Office Action Summary	Application No. 10/728,284	Applicant(s) DEGEN ET AL.	
	Examiner Timothy M. Ayres	Art Unit 3637

DETAILED ACTION

Lin '967 Figure 6

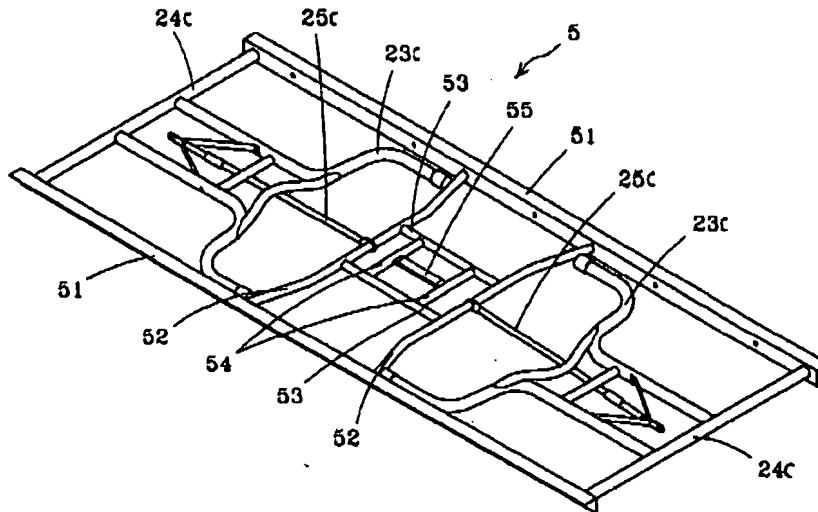
6. Claims 21, and 22 are rejected under 35 U.S.C. 102(e) as being anticipated by US Patent Publications 2003/0233967 to Lin. In the embodiment in figure 6 Lin teaches a table with a table top (1). The table top (1) has a top surface and a bottom surface. Figure 6 teaches an alternative frame structure (5) made of metal to substitute the frame structure (2) of figure 1 and 2. A mounting structure (12) is centrally disposed on the bottom surface. The mounting structure (12) includes a first connecting member (A') and a second connecting member (B'). A first and second leg assembly (23c,24c) is attached to the table top. A first support assembly (25c) is attached to the first leg assembly (23c,24c) and to a first connecting rod (52). The first connecting rod (52) is connected to the first and second connecting member (A', B') and second connecting rod (52) is also connected to the first and second connecting member (A', B'). A second leg assembly (23c,24c) has a second support assembly (25c) connecting to the second connecting rod (52). A handle has a handle portion (55) that is attached to the inner side of the first connecting member (A') and inner side of the second connecting member (B') via the connecting portion (54). A space is below the handle portion (55) to allow a person to place their fingers around the handle portion (55). The handle (55,54) is formed separately from the connecting members (A', B'). The connecting portion (54) and the handle portion (55) is formed from two pieces of metal welded together making them formed discretely. The connecting members (A', B') are formed integrally formed with the table top (1). The table top (1) is made of plastics by blow molding method, which means that it has a hollow interior. First and second brackets (53) connect to the

inner side of the first and second connecting member (A', B') and to connecting portion (54) of the handle (55,54).

the connecting portion and the handle portion as taught by Lin in figure 6 is considered L-shaped to the same level that the applicant's handle is L-shaped.
